10 January 2012

Project No. 09-1373-1004.9500

RESPONSE TO ADDITIONAL INFORMATION REQUESTS NICO DEVELOPER'S ASSESSMENT REPORT

Photo 2: Upstream View of Wetland from the Base of the Beaver Dam, 25 August 2011.

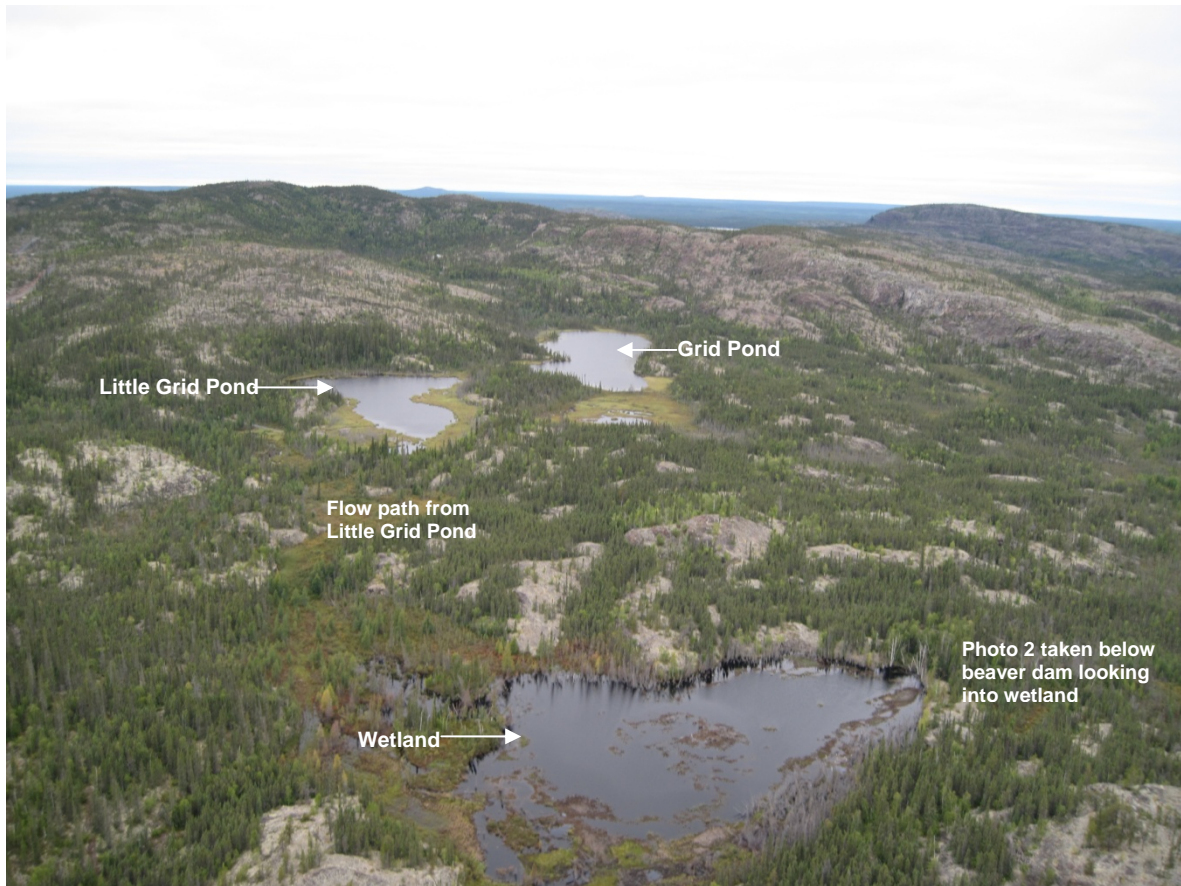
Please provide additional information, observations and/or notes regarding the lack of connectivity between Little Grid Pond and Nico Lake.

Over most of its length, the watercourse from Little Grid Pond to Nico Lake meanders through sedge meadows and complexes of willows as shown in Photo 1. This photo was taken approximately half way between Little Grid Pond and Nico Lake and shows the lack of a distinct channel that would allow for fish passage. A wetland exists approximately 200 metres downstream of Little Grid Pond, which has a large beaver dam on its downstream side (Photo 2). The location of the wetland in relation to Little Grid Pond and the lack of a distinct channel between this pond and the wetland is shown in Photo 3. The overall conclusion from the survey was that there is no connection for fish passage between Little Grid Pond and Nico Lake due to the lack of a distinct channel in most locations and the presence of a large beaver dam on the downstream side of the wetland.
